AMENDMENT OF SOLICITATION/MODIFICATION OF CONTRACT			I. CONTRACT ID CODE	PAGE OF PAGES	
			J	1	5
2. AMENDMENT/MODIFICATION NO. 0001	3. EFFECTIVE DATE 14-Feb-2006	4. REQUISITION/PURCHASE REQ. NO.		5. PROJECT NO.(If applicable)

14. DESCRIPTION OF AMENDMENT/MODIFICATION (Organized by UCF section headings, including solicitation/contract subject matter where feasible.) The above numbered solicitation for Lake Pontchartrain and Vicinity, Phase II Floodwall Repair, London Avenue Canal Breach Near Robert E. Lee Blvd. is hereby amended as follows: The proposal due date is extended. The new proposal due date is 17 February 2006, 10:00 a.m. local time (New Orleans, LA). (SEE CONTINUATION SHEET)					
Except as provided herein, all terms and conditions of the document referenced in Item 9A or 10A, as heretofore changed, remains unchanged and in full force and effect.					
15A. NAME AND TITLE OF SIGNER (Type or print)			16A. NAME AND TITLE OF CONTRACTING OFFICER (Type or print)		
			TEL: _____ EMAIL: _____		
15B. CONTRACTOR/OFFEROR _____ (Signature of person authorized to sign)	15C. DATE SIGNED	16B. UNITED STATES OF AMERICA BY _____ (Signature of Contracting Officer)		16C. DATE SIGNED 14-Feb-2

**BREACH NEAR ROBERT E. LEE
TIE-IN DETAILS, SOUTH END (EAST SIDE)**

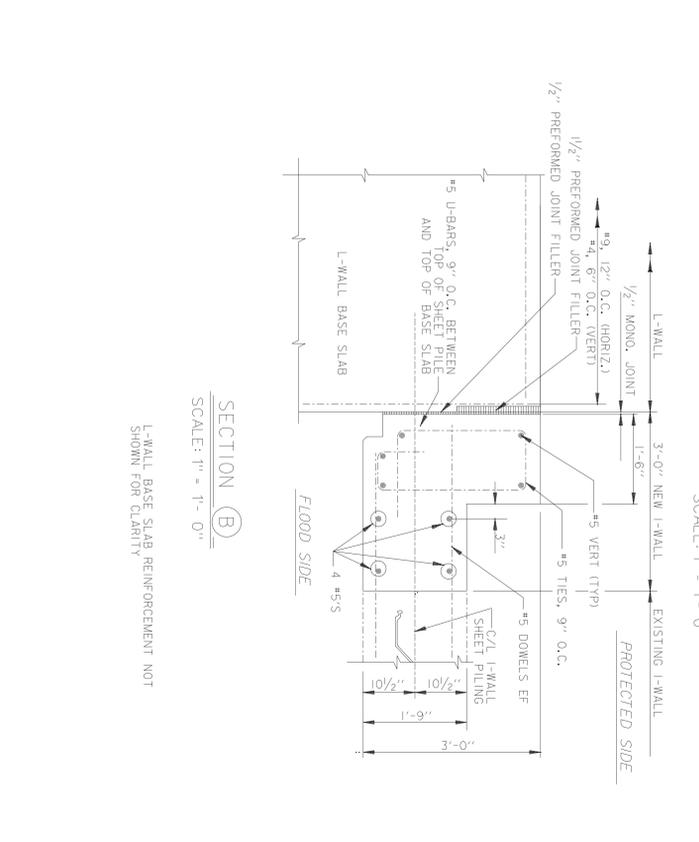
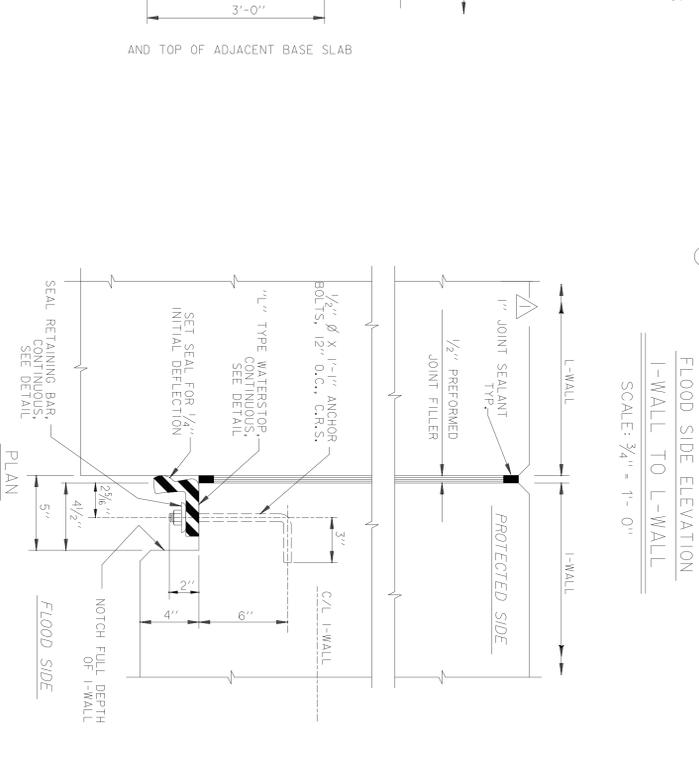
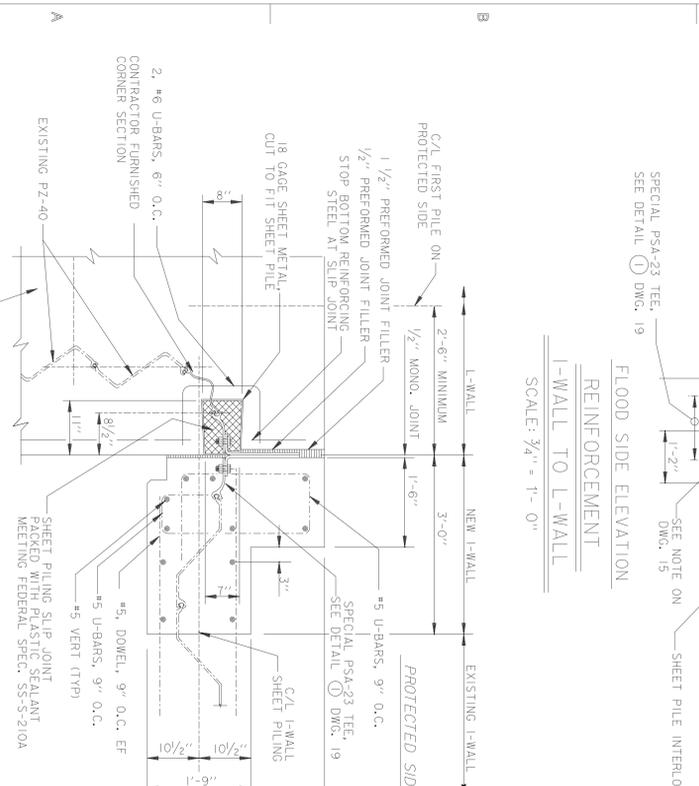
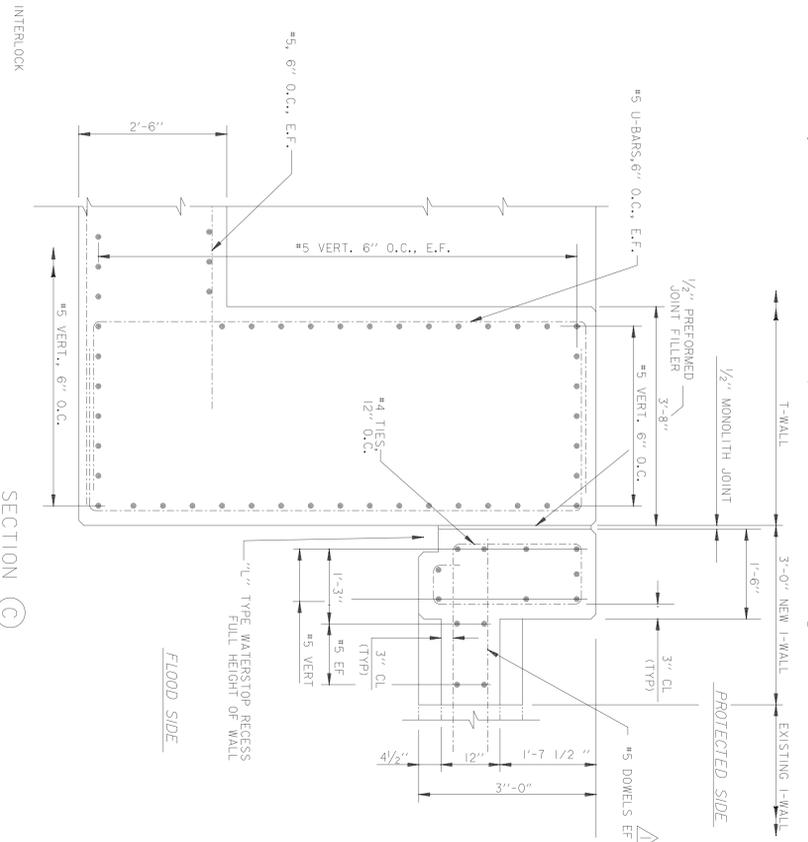
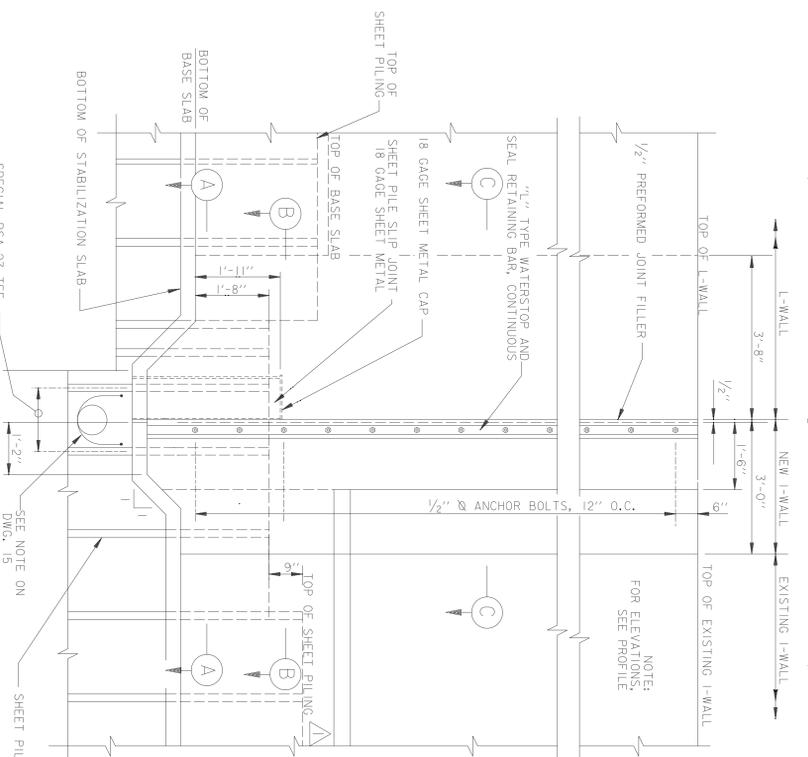
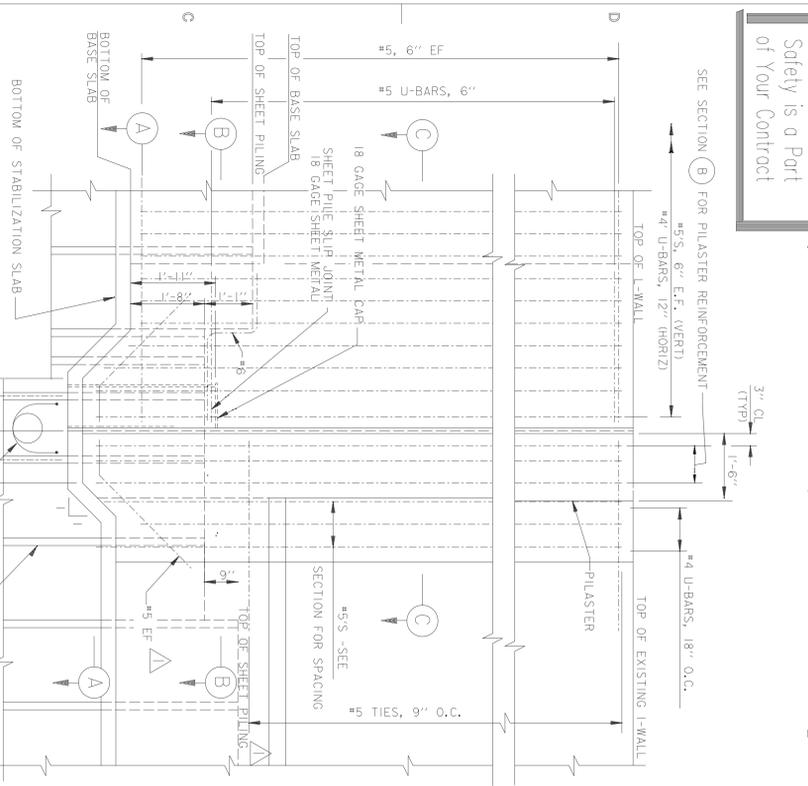
(d). Delete drawing 21 of 21, in its entirety and replace with revised drawing 21 of 21.

MARK	DESCRIPTION	DATE	APPR	MARK	DESCRIPTION	DATE	APPR
	GENERAL REVISIONS TO DRAWING	2/14/06	CPB
